**Proposed Residential Development,
Plane Street, Primrose Hill,
Huddersfield**

**Designers Response to Stage 1
Road Safety Audit**

Report Ref:	11293/JT/003/02	June 2020	
Author:	John Turner		
Checked & Approved:	Karen Smith MIHE	Date:	30 June 2020

Drawing Reference: Stage 1 RSA Marked up Plan

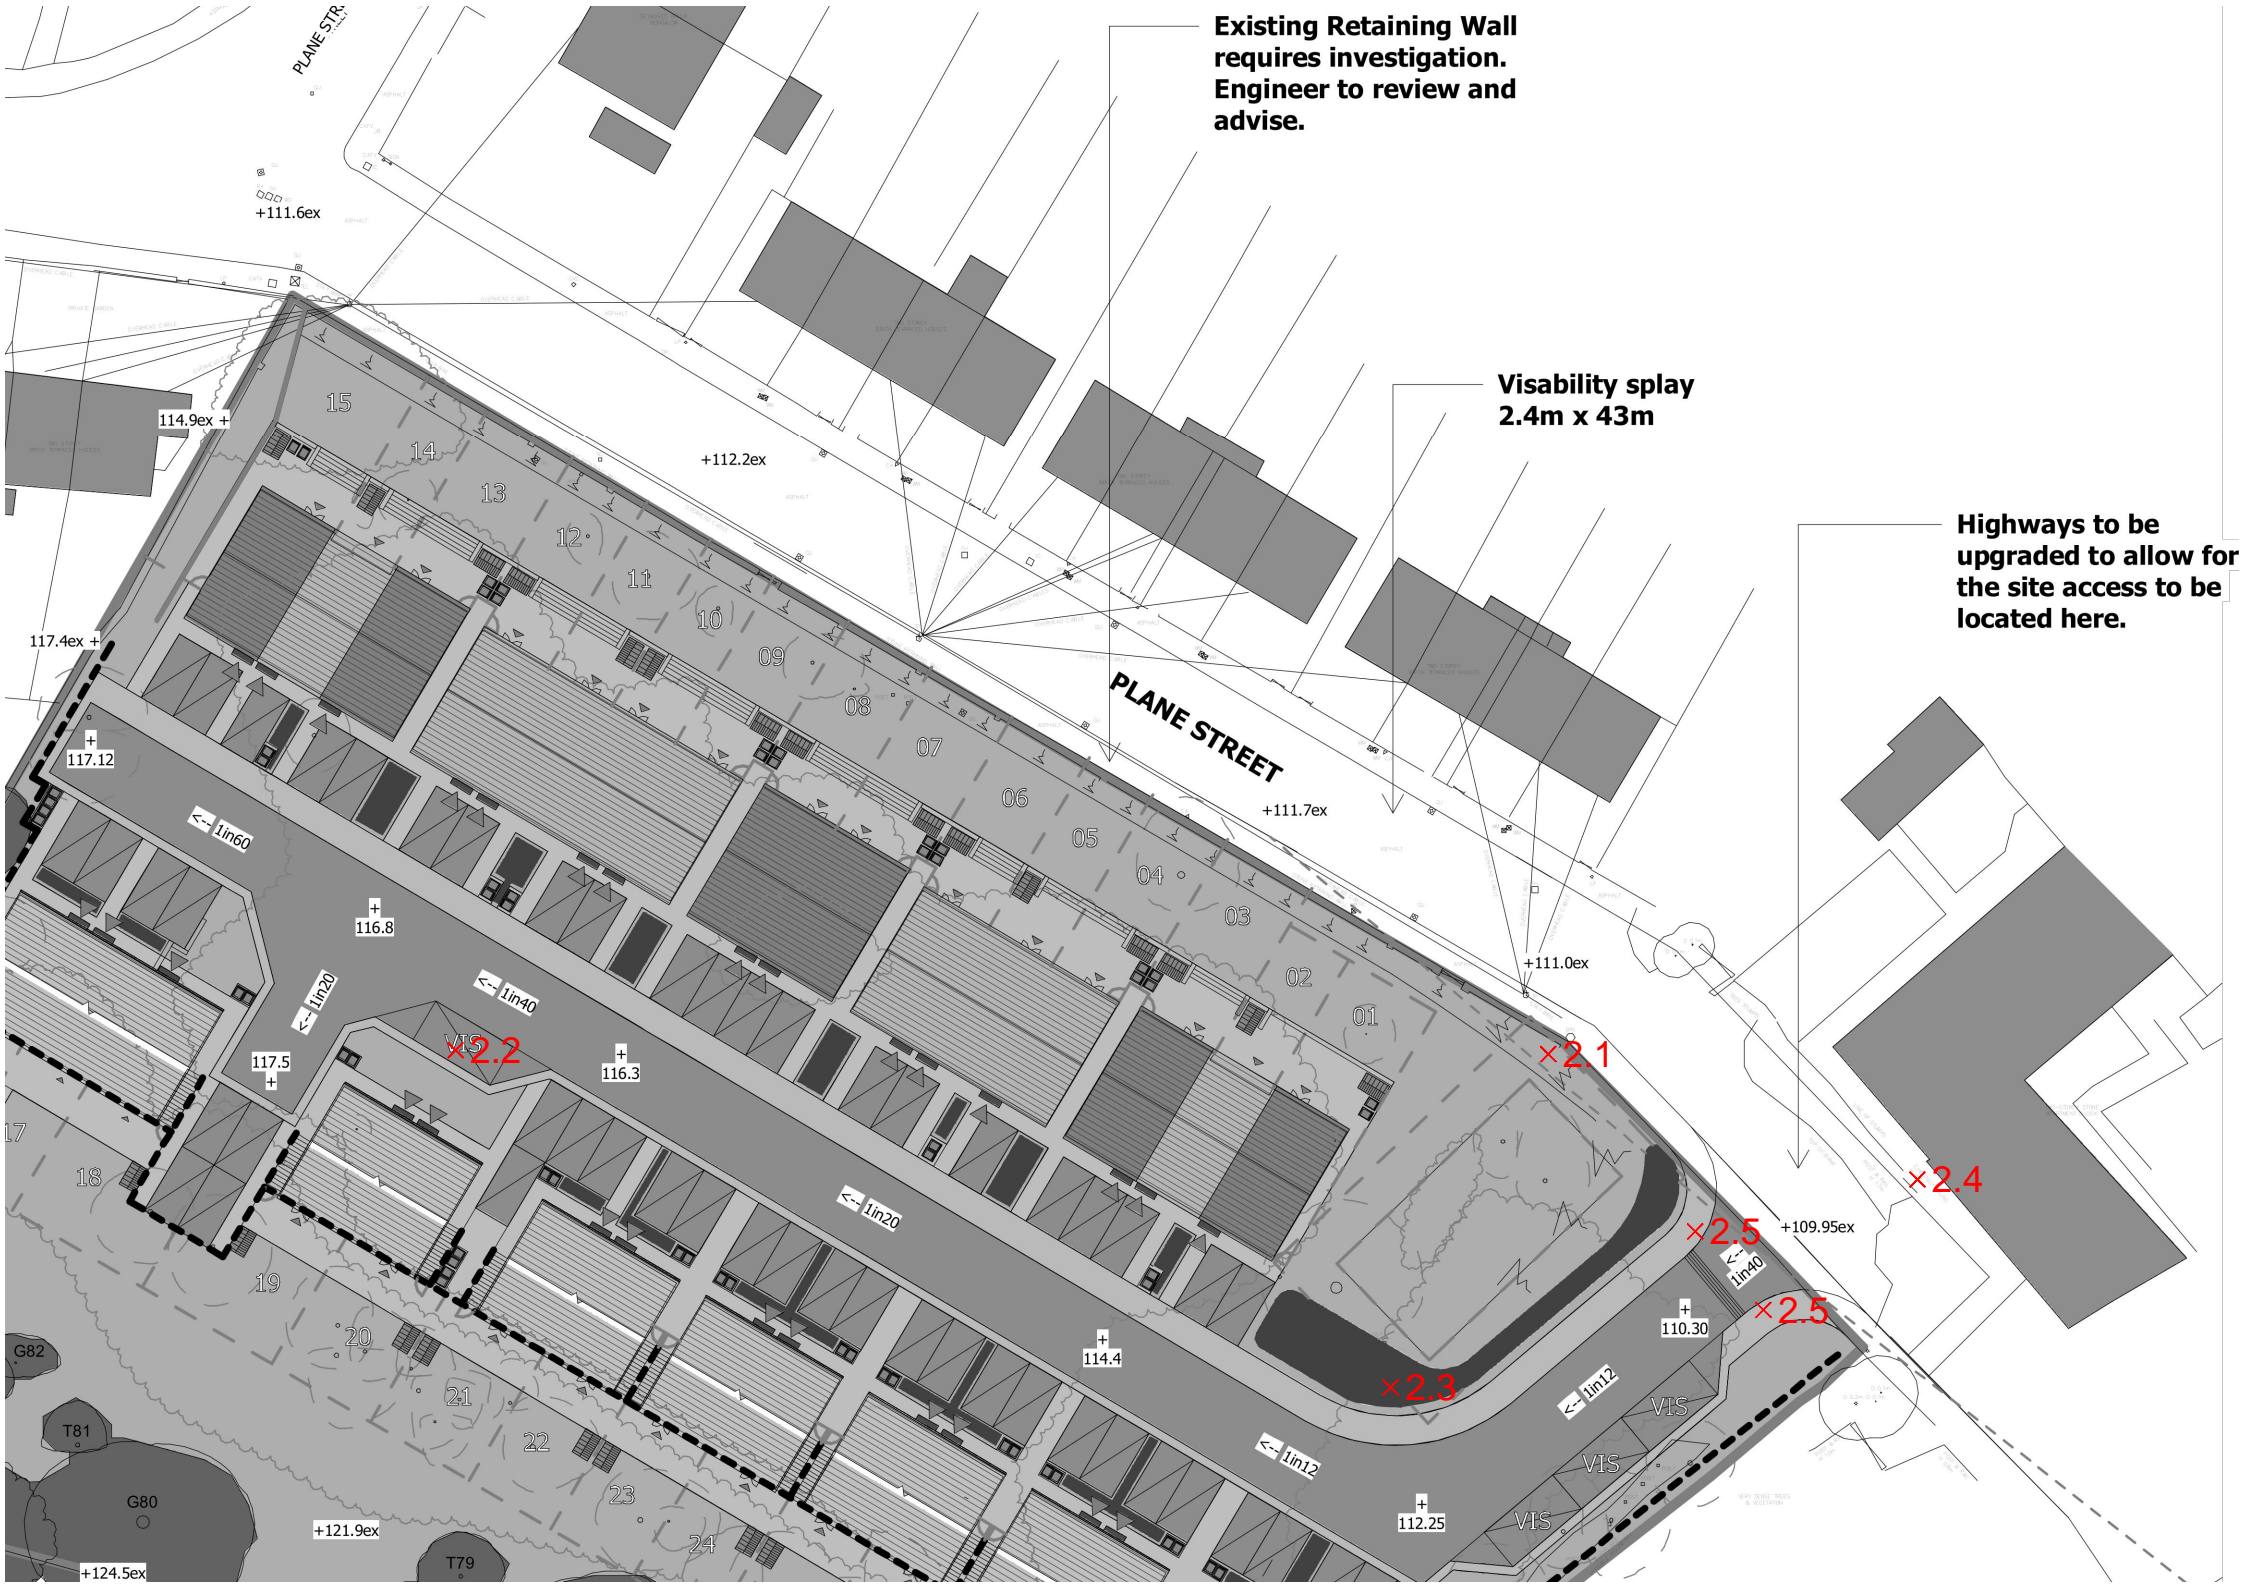
**Existing Retaining Wall
requires investigation.
Engineer to review and
advise.**

**Visibility splay
2.4m x 43m**

**Highways to be
upgraded to allow for
the site access to be
located here.**

11293-004 – Visibility Splays at Site Access

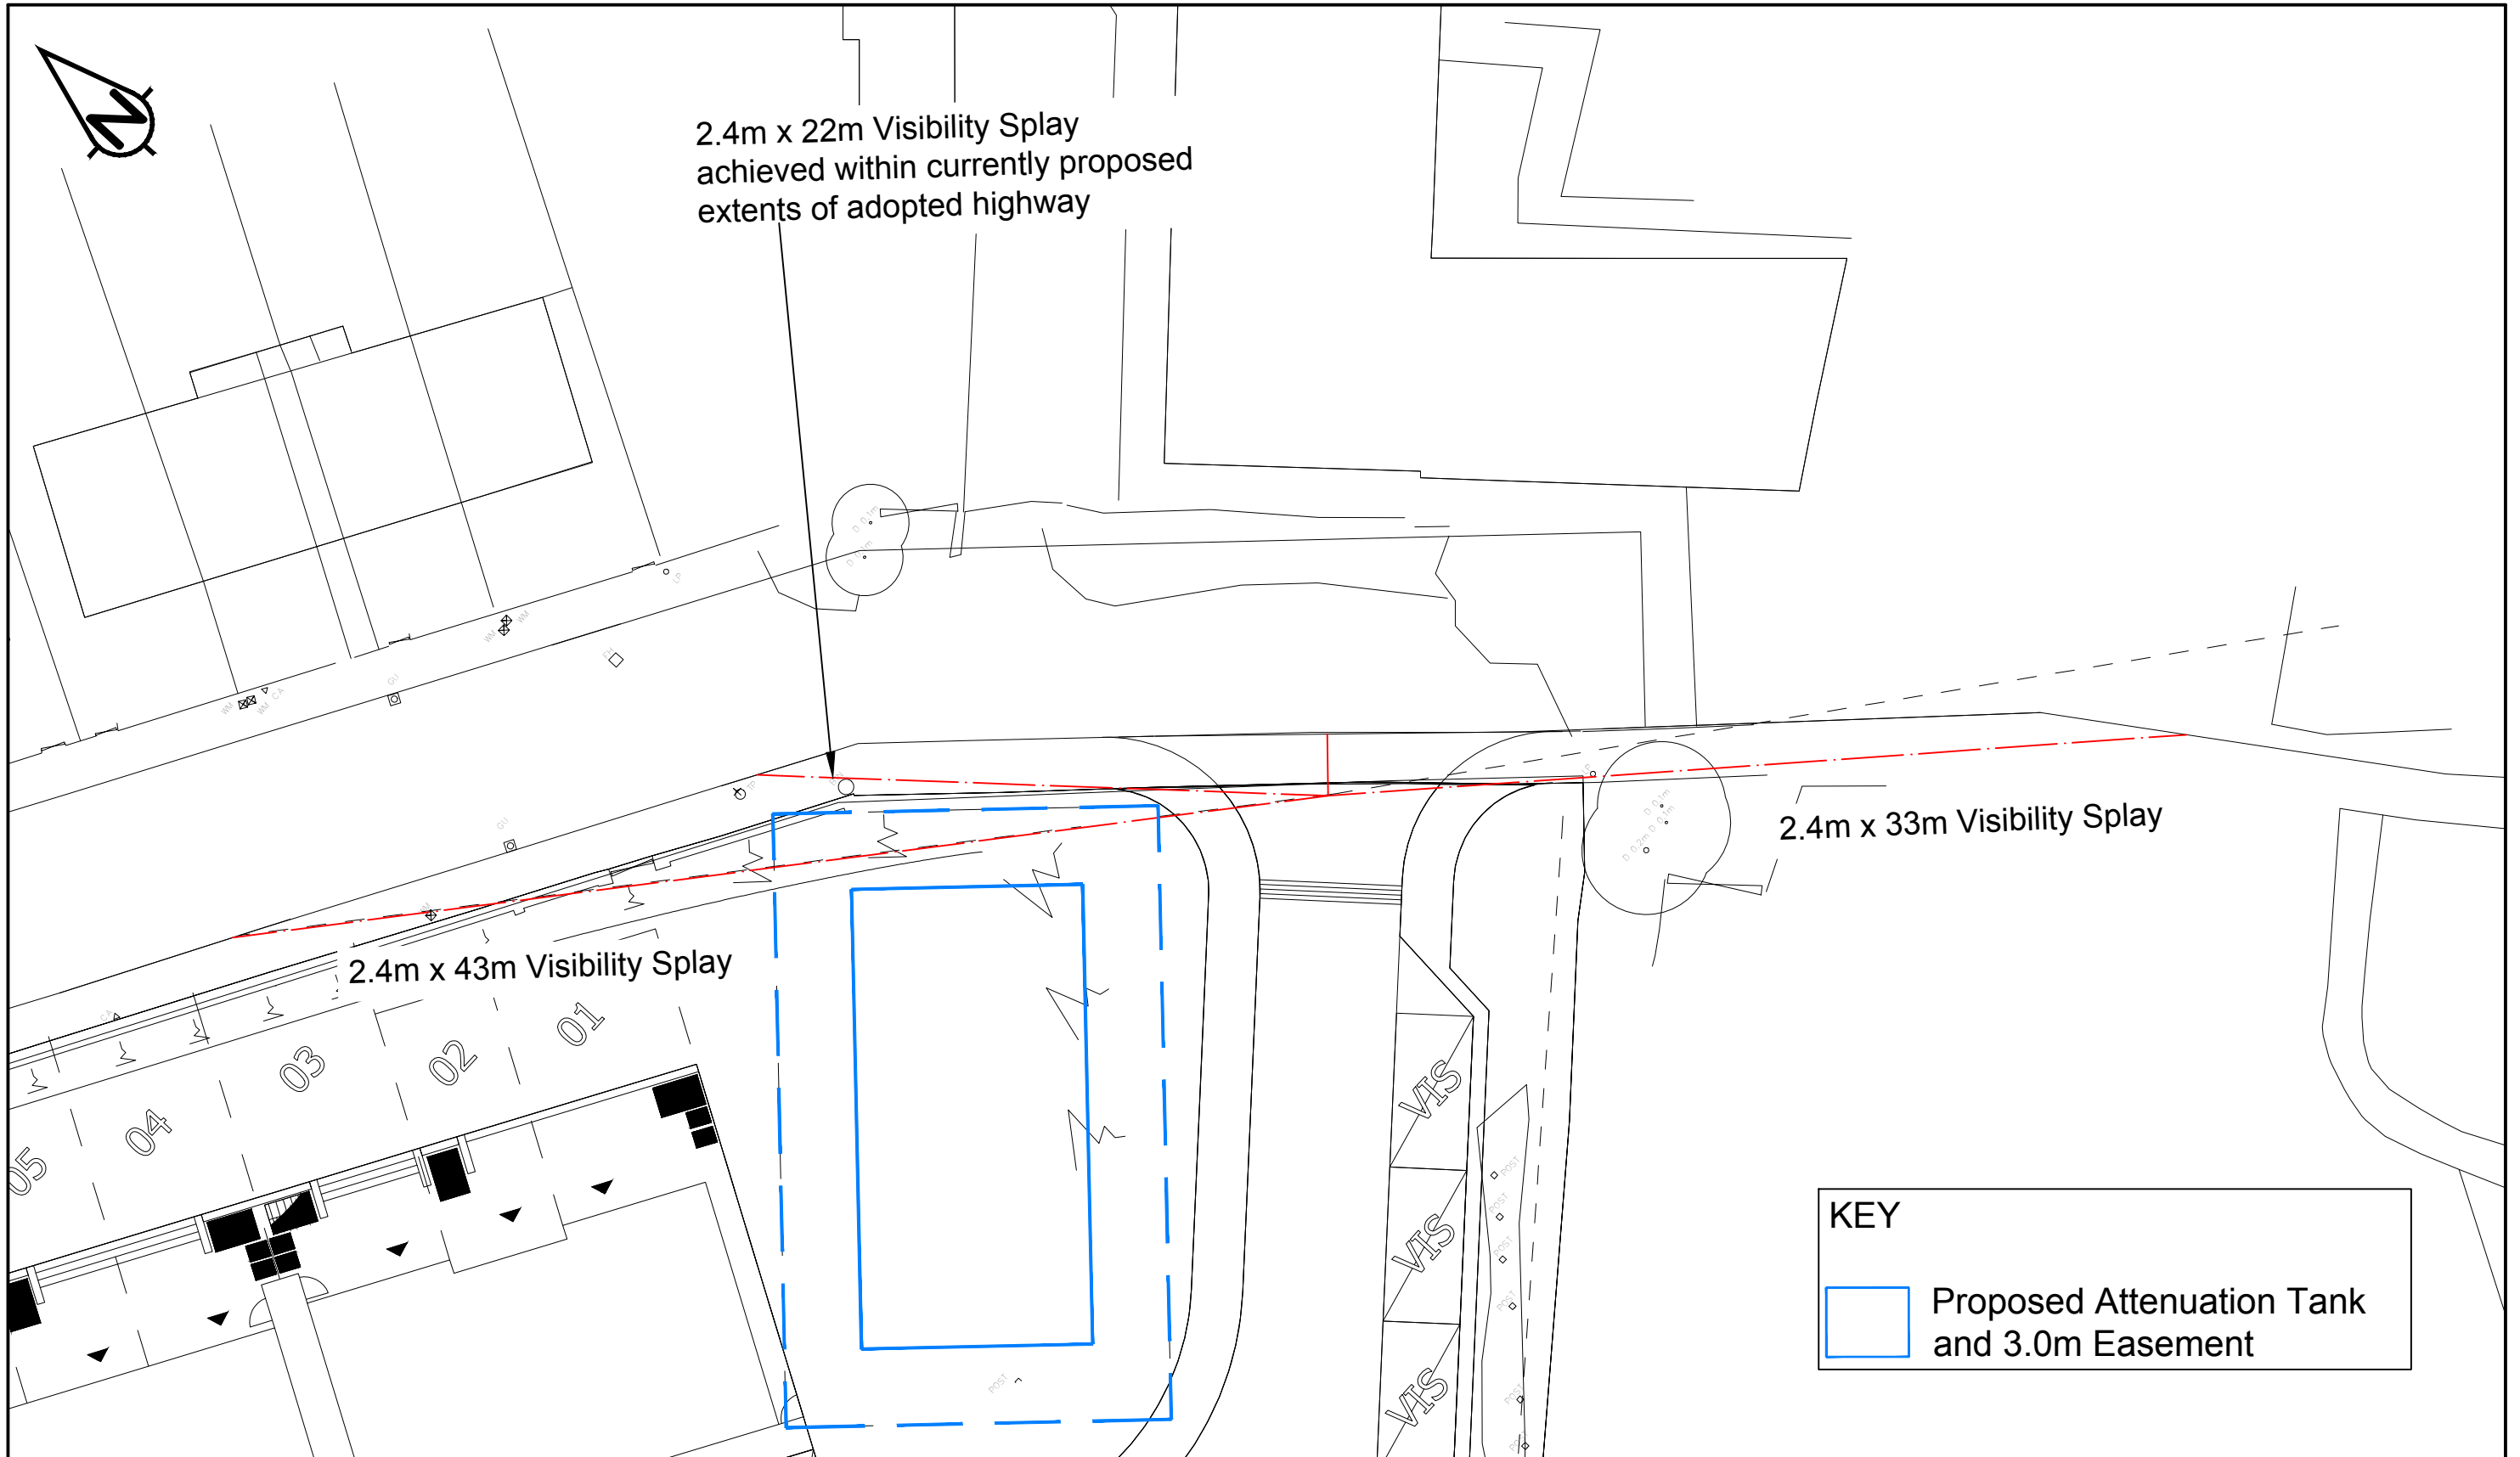
Summary: The 2.4x43m visibility splay to the west of the site access is shown passing over the existing site boundary wall. Whilst it is assumed that the wall will be set back behind the proposed visibility splay, this is not shown on the plans and the ability to do so may be affected by the proposed attenuation tank and easement. Should the wall not be set back, this may restrict visibility at the site access below acceptable minimum levels, which could result in turning type collisions at the junction.

Recommendation: It is recommended that the site access visibility splays are kept clear of any significant vertical obstructions, including walls and larger street furniture (e.g. the existing waste bin)

Summary: There is a relatively tight bend on the site access road, where it would not be possible for a refuse vehicle to pass a car. Whilst this is not necessarily a significant issue on its own due to the low traffic flows that is expected along the road, it is unclear if there will be adequate forward visibility around the bend to allow drivers to give-way before they meet an oncoming vehicle at the bend. As such, this could lead to head on collisions at the bend

Recommendation: It is recommended that adequate forward visibility is provided at the bend that allows drivers to observe an oncoming vehicle; and then wait as necessary before the bend to allow oncoming vehicles to pass.

2.1.1 Designers Response:-*The Auditors recommendation is accepted. The visibility from the site access will be kept clear of significant obstructions. As part of the proposed development, the wall along the site frontage is to be demolished in the location of the access and therefore once the site is operational this will not obstruct the required visibility. The drawing attached to this report (Ref: 11293-004) demonstrates the visibility which can be achieved from the proposed site access. During pre-application discussions with Kirklees Council Highways Development Management, officers agreed that they are willing to accept the shortfall of visibility at this particular location. Therefore the visibility from the proposed access is considered to be acceptable in this particular instance.*

Designers Response: *The Auditors recommendation is acknowledged. However, the forward sight stopping distance has been based on the centre line radius of the road being 15m and therefore it is expected that vehicles will be travelling at 15mph or less. Based on Table 7.1 of Manual for Streets there is therefore a requirement to provide forward sight stopping distance of 17m. The drawing attached to this report (Ref: 11293-005) demonstrates that forward sight stopping distance of 17m can be achieved at the internal bend within the site.*

Forward sight stopping distance of 17m based on 15mph expected vehicle speed. Vehicle speed has been based on the centre line radius of 15m.

Swept Path Analysis of
 refuse vehicle turning
 at proposed site access

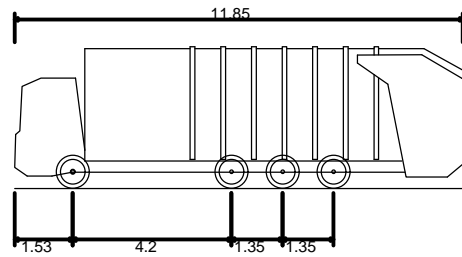
Recommendation: It is recommended that additional visitor parking spaces are provided towards the western end of the site access road, which appears possible by amending the single visitor parking bay in front of No. 19-20. It also recommended that the swept path analysis is undertaken to confirm that refuse vehicles can turn at the extended end of Plane Street next to the site access junction, in the event that the access road still becomes blocked and this area is required to allow a refuse vehicle to turn without reversing all the way back to Malvern Rise.

The swept path analysis drawing attached (Ref: 11293-006) demonstrates that a refuse vehicle will be able to turn at the site access at the extended termination of Plane Street. Therefore in a situation where the site access is blocked, refuse vehicles will be able to turn and not have to reverse the long distance back towards Malvern Rise.
